**ALTERATION TO A HISTORIC PROPERTY STAFF REPORT**

Site:	47 Franklin Street	c.1869 Alonso Bowers House
Case:	HPC 2014.035	Flint Street LHD
Applicant Name:	Barry Abramowitz, Owner	
Applicant Address:	47 Franklin Street, Somerville, MA 02145	
Date of Application:	May 26, 2015	
Legal Notice:	<i>Replace chain link fence with metal fence.</i>	
Staff Recommendation:	Certificate of Appropriateness	
Date of Public Hearing:	June 16, 2015

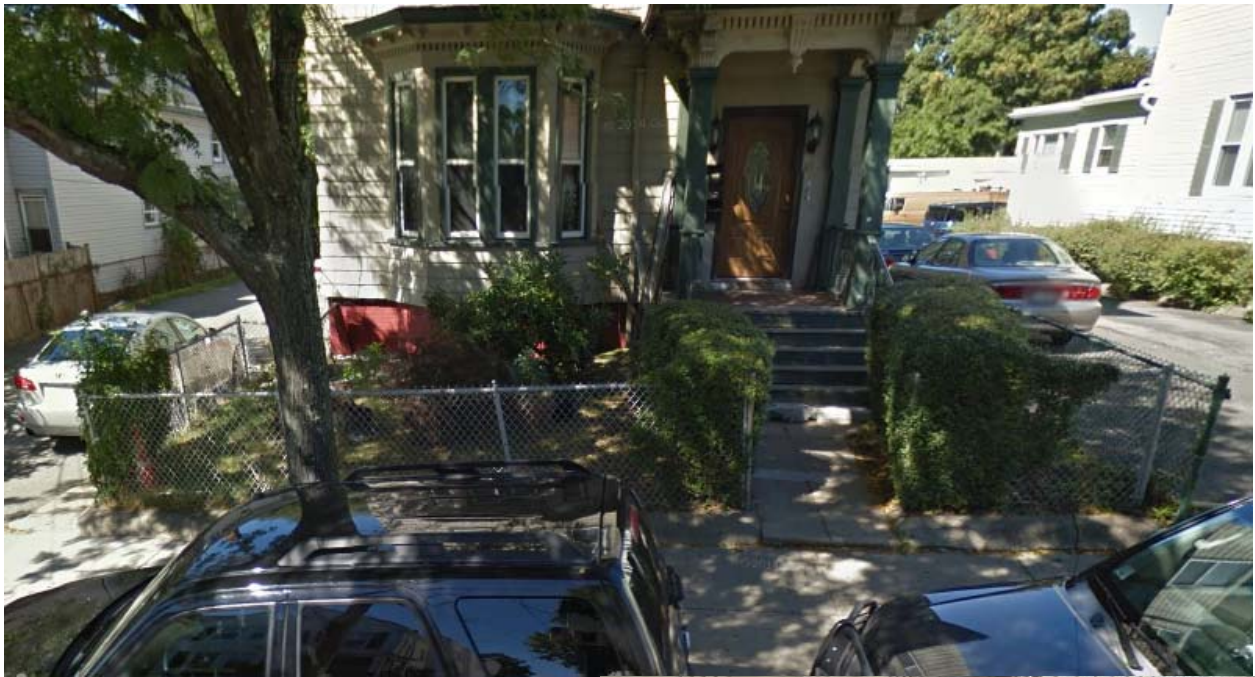
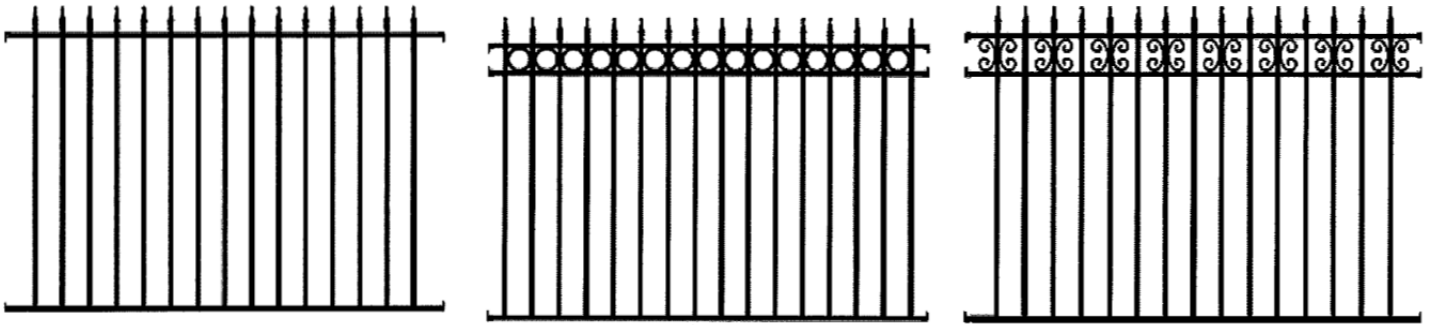
Staff determines that the alteration for which an application for a Historic Certificate has been filed would not be incongruous to the historic aspects or the architectural characteristics of the surroundings and of the historic district and is appropriate for and compatible with the preservation and protection of the Columbus Avenue, Warren Avenue Local Historic District; therefore **Staff recommends that the Historic Preservation Commission grant Barry Abramowitz, owner a Certificate of Appropriateness** for the installation of a short fence, and gate at **47 Franklin Street** with the following contingencies.

1. The chain link fence on either side of the walkway shall be removed;
2. A new iron gate and short fence in the design submitted and attached below shall be installed in the existing location of the chain-link fence;
3. The gate and fence shall be of simple metal pickets; and
4. Historic Staff shall issue a sign-off upon completion of the project that this was done in accordance with the Certificate.
